UNITED STATES PATENT AND TRADEMARK OFFICE

10/734,540

Office Action Summary	Application No.	Applicant(s)	
	10/734,540	YANG ET AL.	
	Examiner	Art Unit	
	Justin Krause	3682

DETAILED ACTION

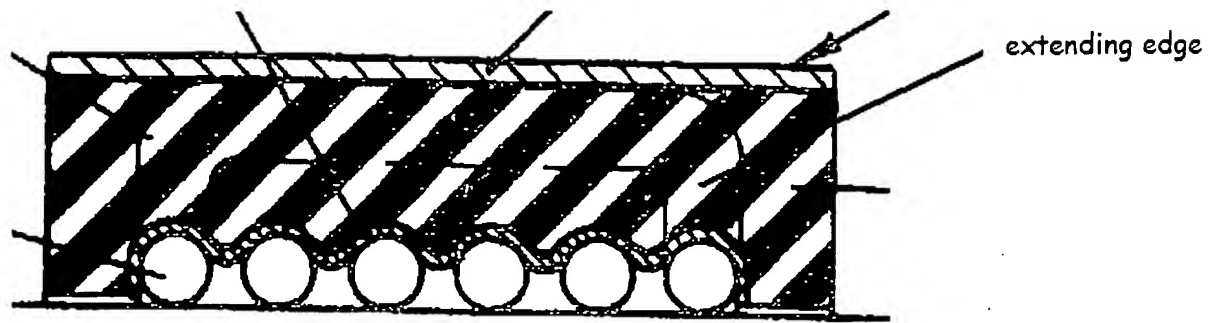
Lundgren discloses a reflow device for a ball screw provided with a recirculating path (6), capable of being fixed to a screw nut assembly and integrally combined with a screw nut, the reflow device including a hard portion (7) and a soft portion (5), the hard portion combined with the soft portion.

Lundgren does not disclose the reflow device wherein the rolling balls are surrounded by the soft portion.

Benton teaches of a reflow device wherein the rolling balls are surrounded by a soft portion (64) to create a low friction endless track for the balls to recirculate (Col 2, line 47-66).

It would have been obvious to one having ordinary skill in the art at the time the invention was made to modify the teachings of Lundgren and surround the reflow path with soft material to create a low friction endless track as taught by Benton.
